CITY OF BLOOMINGTON

**CITY OF BLOOMINGTON
HEARING OFFICER
July 13, 2011 at 2:00 p.m.**

- V-24-11 **CFC, Inc.**
200 S. Madison St.
Request: Variance from signage standards.
Case Manager: Patrick Shay

- V-25-11 **St. Paul United Methodist Church**
4201 W. 3rd St.
Request: Variance from minimum driveway separation standards.
Case Manager: Jim Roach

Double Sided Sign

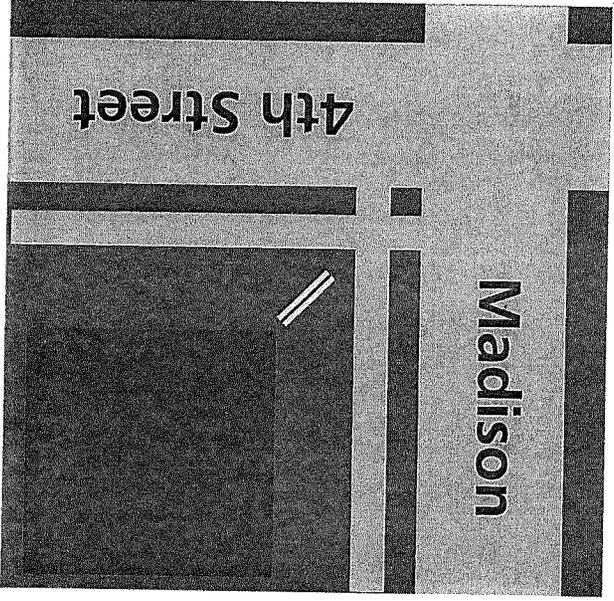
The petitioner proposes to remove the existing freestanding sign and erect a new double-sided freestanding sign in the same location, at a forty-five degree angle to the corner. The sign face area will be 3' in height and 5' in width.

The Unified Development Ordinance (UDO) does not allow a freestanding sign in the CD district unless the primary structure on a lot is set back from the public right of way by a minimum of 15'. The petitioner is requesting a variance to allow a freestanding sign on a property with a primary structure set back less than 15' from the public right-of-way. The proposed sign will meet all other standards of the UDO.

STAFF FINDING: Staff finds no injury. There will be no change in the use of the property as a result of the proposal. The proposed sign will be smaller than the existing sign and meet current sign area and height standards. Although the proposed sign will be located within the public right-of-way, it will be located behind the sidewalk and will not obstruct driver, pedestrian, or bicyclist vision.

RECOMMENDATION: Based upon the written findings above, staff recommends approval of the variance request with the following conditions:

1. A sign permit is required prior to placement of the sign.
2. An encroachment from City of Bloomington Public Works is required prior to the placement of the sign.
3. Sign height shall limited to a maximum of 4'.
4. Landscaping that meets the provisions of BMC 20.05.079(j)(1)(E) is required.

V-25-11
 Site Plan

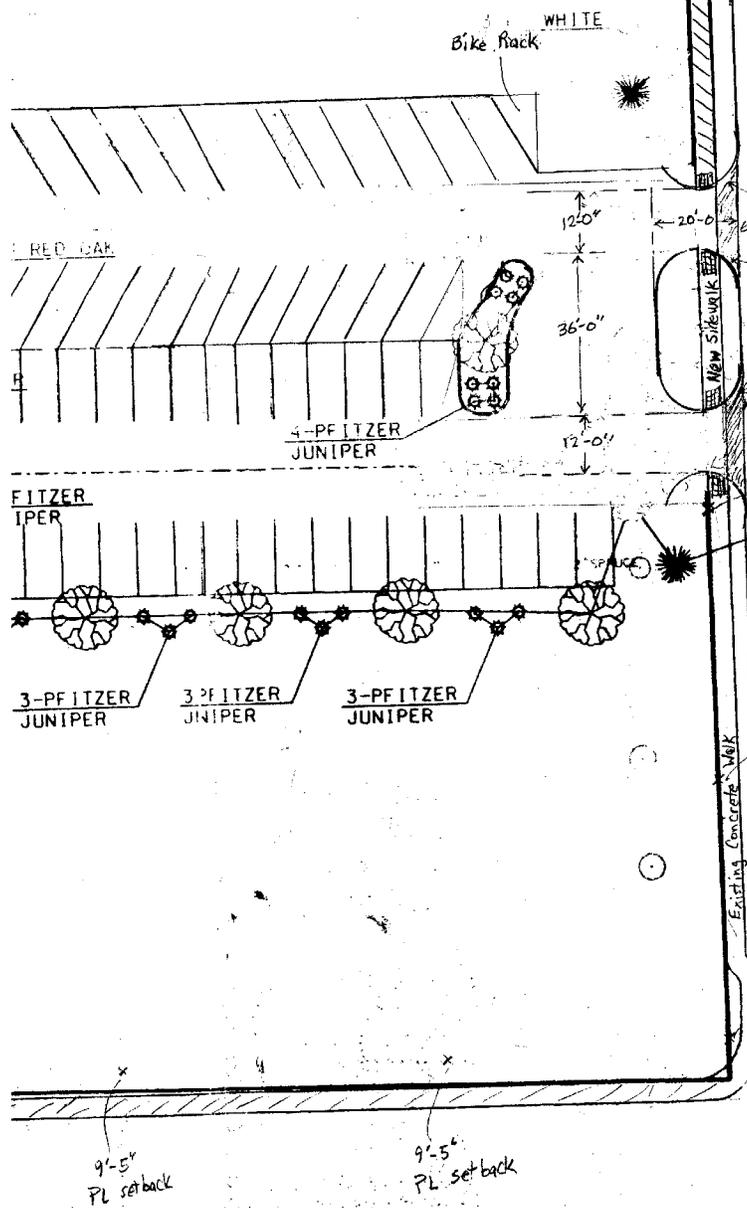
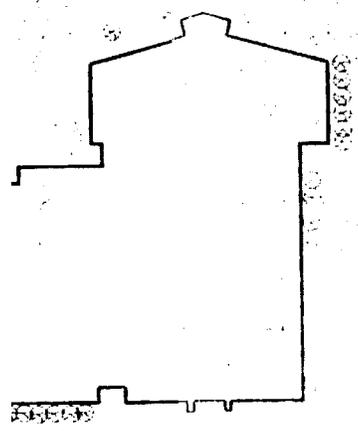
Instead of a single 24 foot wide drive, the petitioner proposes to separate the drive into a 12 foot wide in-bound lane and a 12-foot wide out-bound lane, separated by 36 feet. The petitioner conditions that this arrangement will allow for better access for larger vehicles given the unusual shape of the parking lot island immediately west of the entrance. The UDO requires a minimum 100 foot separation between drive-cuts. The petitioner is requesting a variance from the minimum driveway separation standards.

Staff's Finding: Peculiar condition is found in the obtuse angle of the parking lot island. This island makes it difficult to design a single drive-cut that will allow for both in-bound and out-bound traffic, while allowing for cars to circle the island. Peculiar condition is also found in that the petitioner is required to retrofit a drive-cut to meet UDO maximum width standards, while still accommodating the existing design and use of the parking lot. Practical difficulty is found in the arrangement of the existing parking lot that does not meet the UDO standards. If the variance is denied, the petitioner will likely have to completely re-design the parking lot to allow for a 2-way drive, which will also likely mean re-building the island, cutting down a tree and relocation of a parking lot light.

RECOMMENDATION: Based on the written findings, staff recommends approval with the following conditions:

1. Each individual drive-cut can not exceed 12 feet in width.
2. Each individual drive-cut must only permit one-way traffic.
